**Flood Control Project Maintenance
Levee Inspections**

Maintenance Issue Types Only, Levee Inspection Report By Mile - Fall 2023

Reclamation District No. 0784 Plumas Lake

Photo 1 of 1 : FA_2023_RD0784_184_2_20231101_00002.jpg

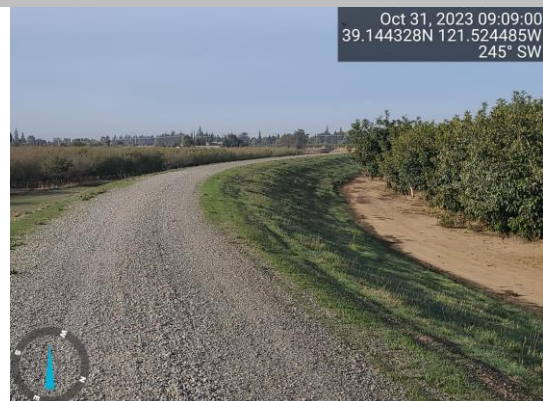
LM Start	0.12	Rating **	A	Issue No.	2
LM End	3.79	Issue Type +	Ma	Location *	WS
Category	Earthen Levee			GPS Latitude/Longitude	
				Start	End
Item	Vegetation			39.135126°	39.165433°
				-121.550051°	-121.495853°
DWR ID	DWR_RD0784_07_f_2023_2				
Comment Code					
V1 : Control annual grass and weeds on the levee slopes and easements.					
Inspector Comment					
Annual vegetation is well maintained, Fall 2023.

View of annual vegetation on the waterside slope, Fall 2023.
